Restriction nr2

About replacing the SP100F, SP130F, SP140F and MIS10006, MIS10007, MIS10008, MIS130

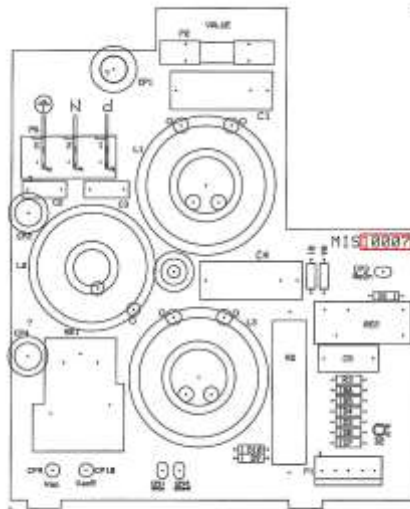
When replacing SP100F, SP130F or SP140F or MIS10006, MIS10007, MIS10008, MIS130 in an amplifier you need to make sure that one of the 33Ω resistor is active either R19 on SP100F/SP130F/SP140F or R5 on MIS100/MIS130. If both are active you will have to disable one of them.

Picture below shows the placement for R19 on SP100F, SP130F and SP140F. The resistor on the SP130 and SP140 may already been disabled by a trace on the back of the board, make sure to check this before you disable any of the two resistors.
